Product Change Notification

Change Notification #: 113154 - 00
Change Title: Intel® Server System R1304GZ4GS9
PCN 113154-00, Product Design
Update the 750W Common Redundant Power
Supply FXX750PCRPS Firmware and Add a
Mylar Bumper
Date of Publication: July 17, 2014

Figure 1. Example of the mylar bumper on the side of the optical drive bay

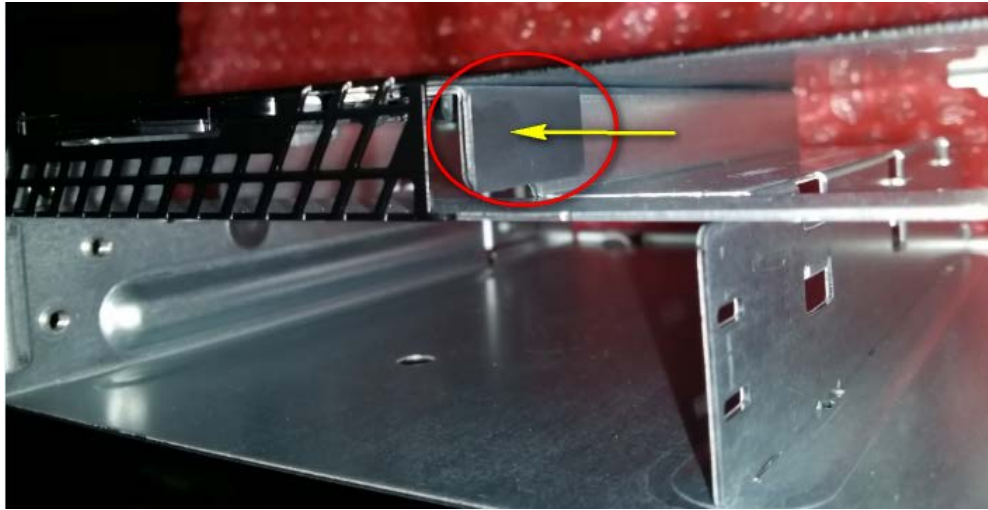
2. Add a mylar bumper on the side of the optical drive bay to improve the fit of the optical drive mechanical assembly. See the image below:
